# Daimler Trucks North America LLC

June 2018  
FL769  
Interim Recall Notice  
NHTSA #18V-253 (School Buses)  
#18V-254 (Non-School Buses)

### Subject: TBB SynTec S3B Seat Frames (Restraint Seats)

**Figure 3**

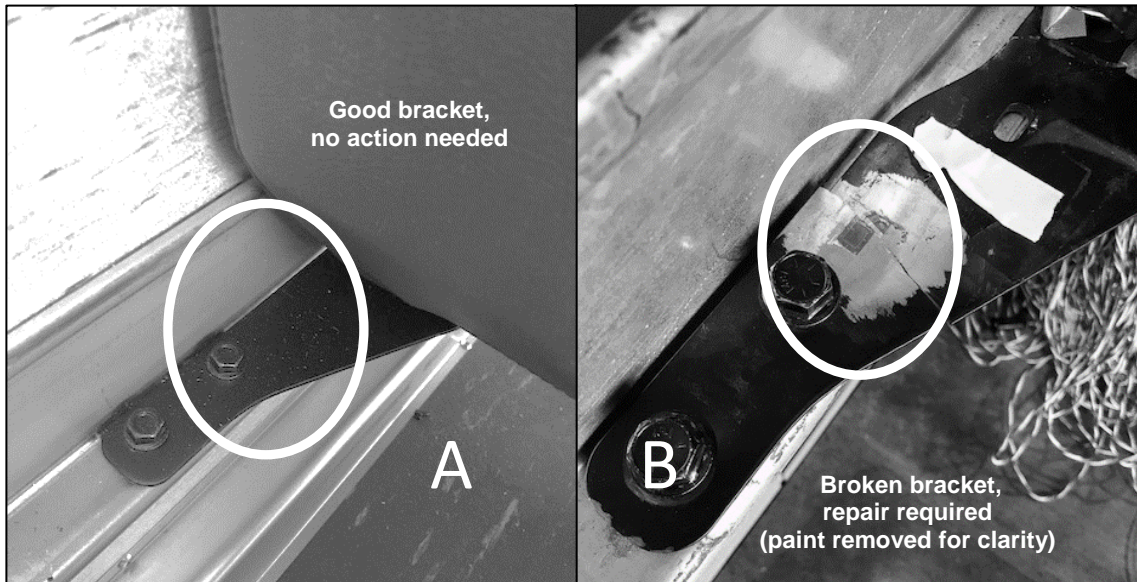
2. Is the bracket intact? Is the bracket cracked or broken? See **Figure 3, Items A and B.**

If a cracked or broken seat mounting bracket is found, please contact your Thomas Built Buses dealer as soon as possible to have it repaired at no charge.
